PARAPETS HEIGHT REDUCTION

PROJECT  
ADAMSTOWN STATION BLOCKS ACD

DRAWING  
BLOCK A ELEVATIONS PODIUM

STATUS CODE: DRAWING NUMBER REVISION  
S2 ADC3-HJL-ACD-ZZ-DR-A-P2011 P02

1 Block A - East Elevation Podium  
1 : 200

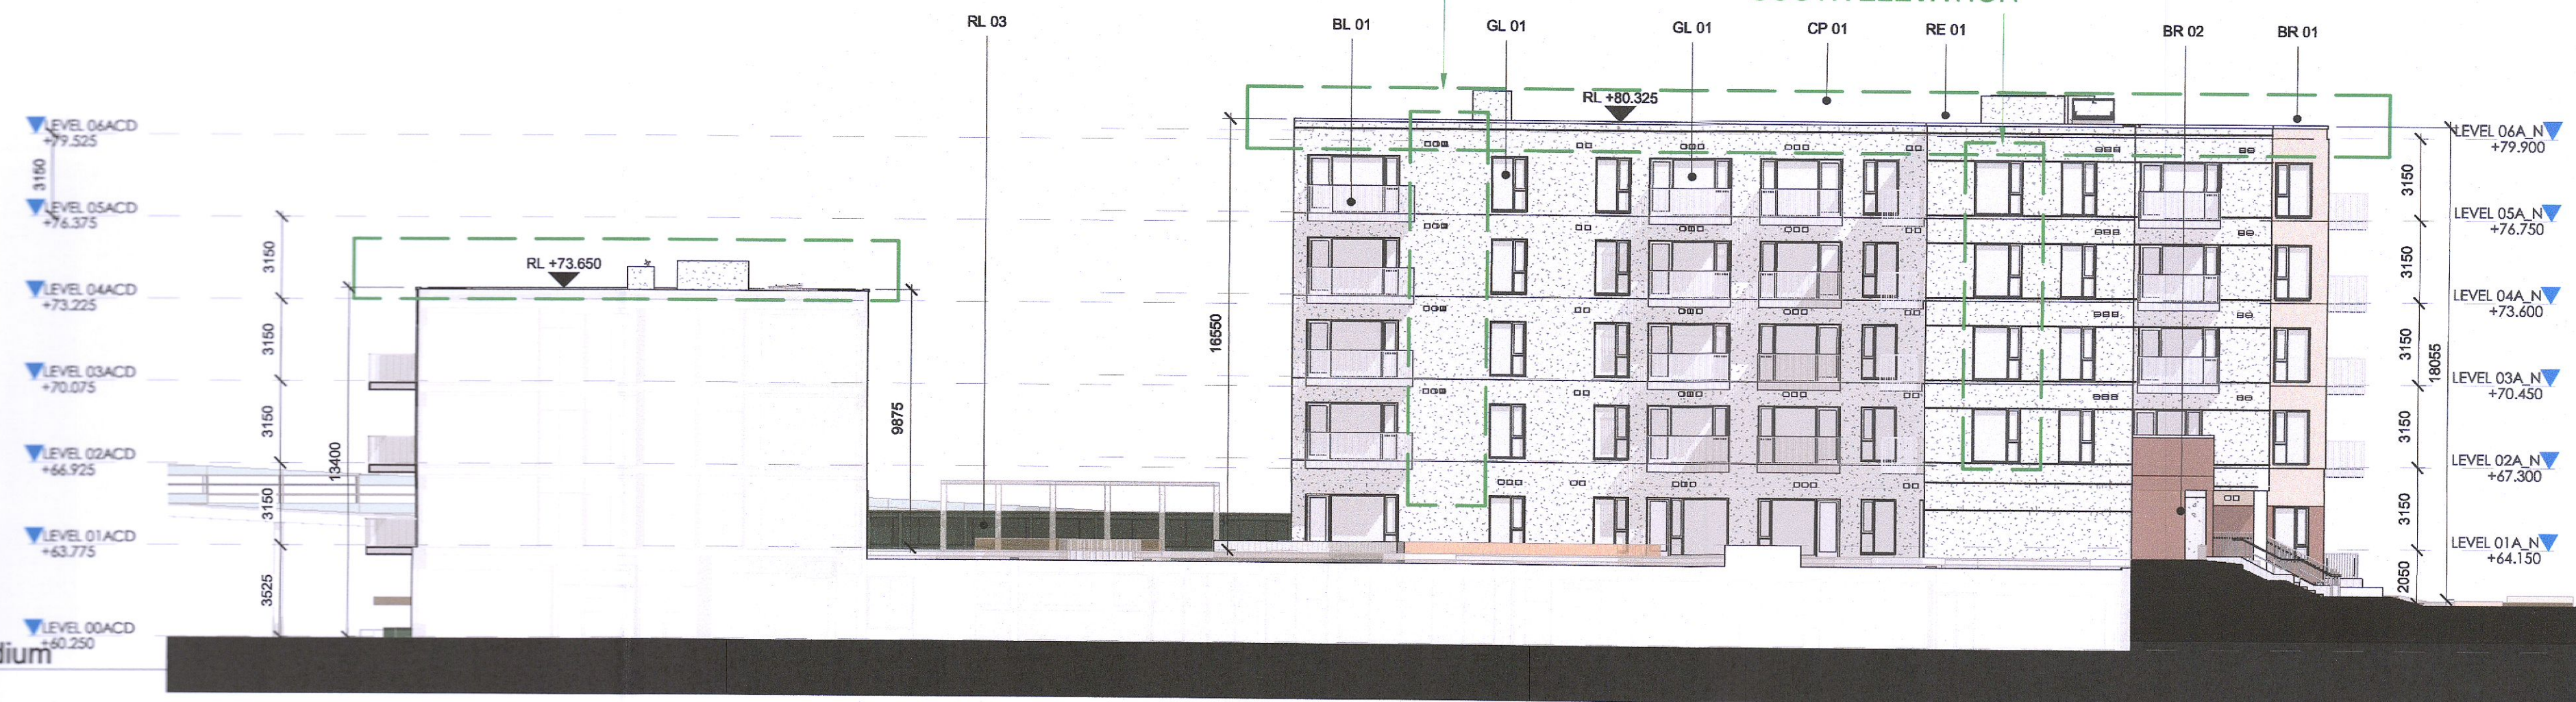
WINDOWS REMOVED DUE TO DESIGN CHANGES  
INTERNAL LAYOUT CHANGES - WINDOWS RELOCATED FROM SOUTH ELEVATION

3 Block A - South Elevation Podium  
1 : 200

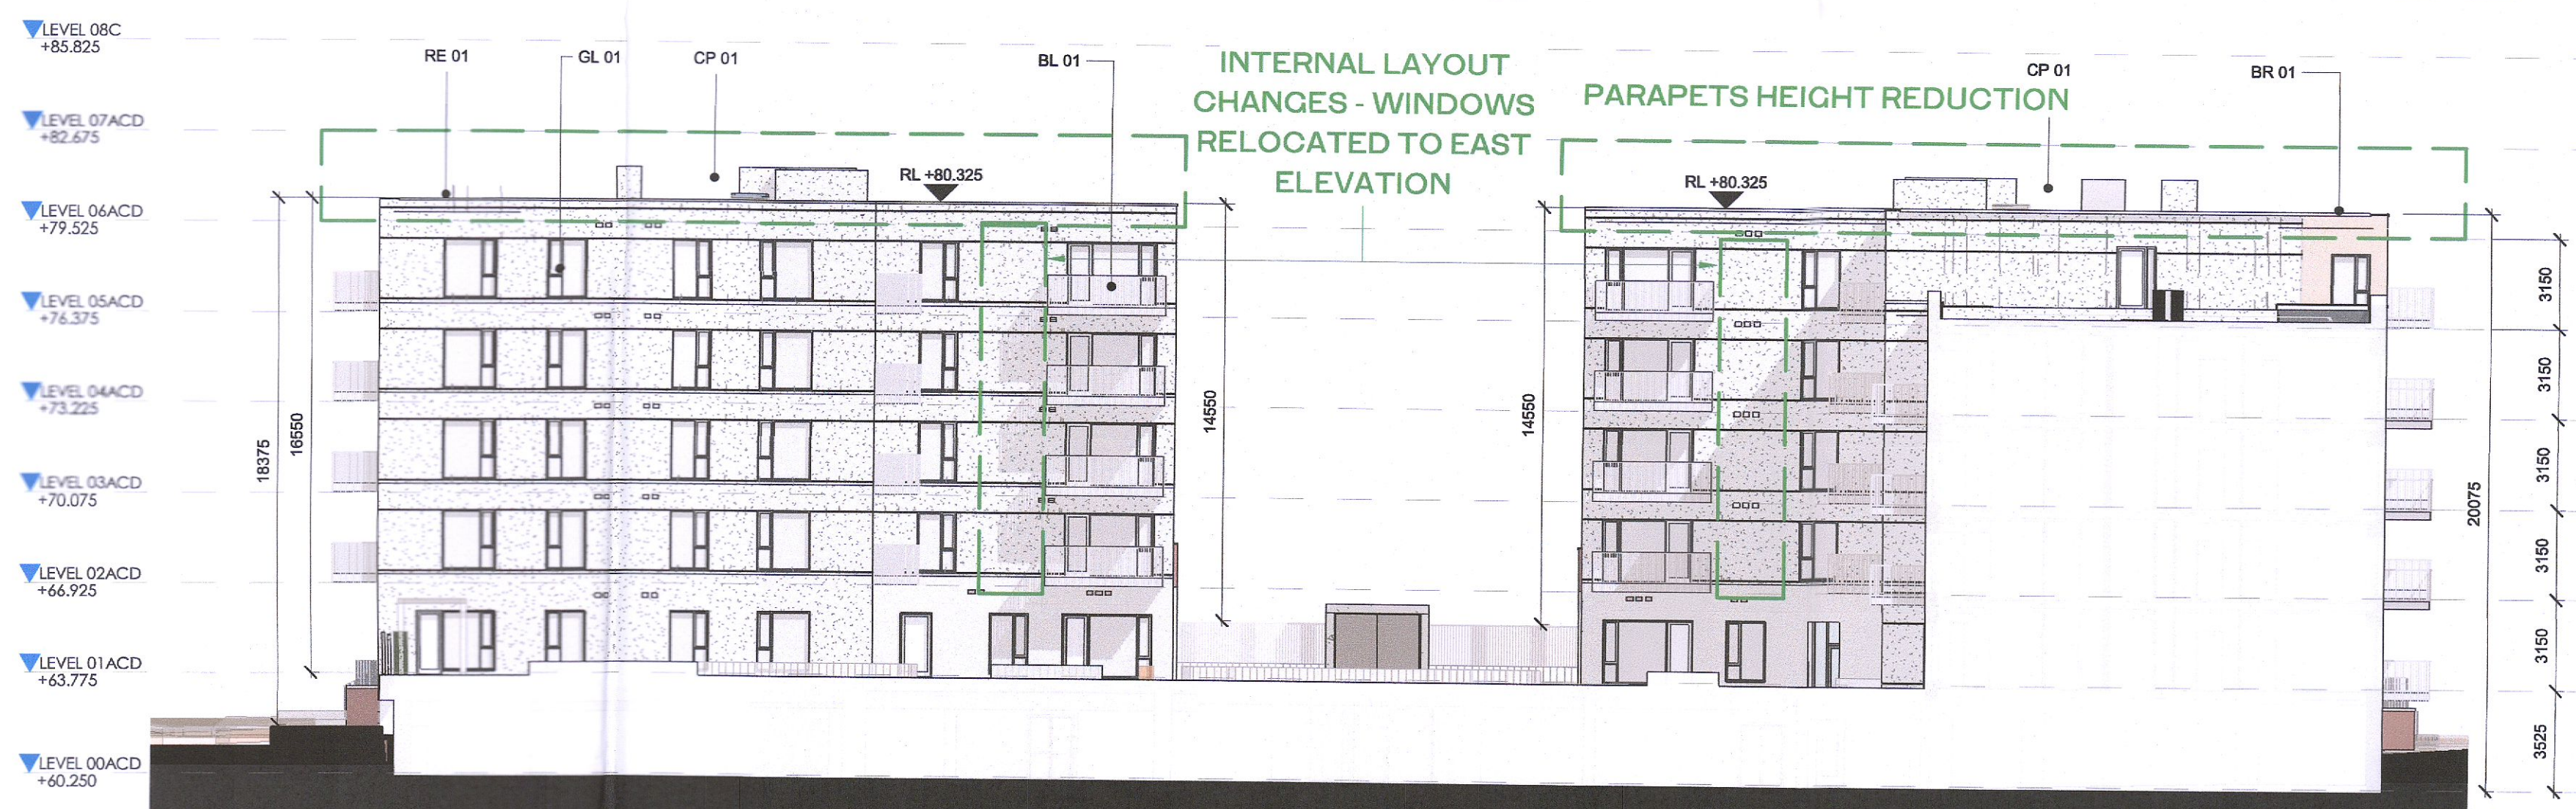
INTERNAL LAYOUT CHANGES - WINDOWS RELOCATED TO EAST ELEVATION  
PARAPETS HEIGHT REDUCTION
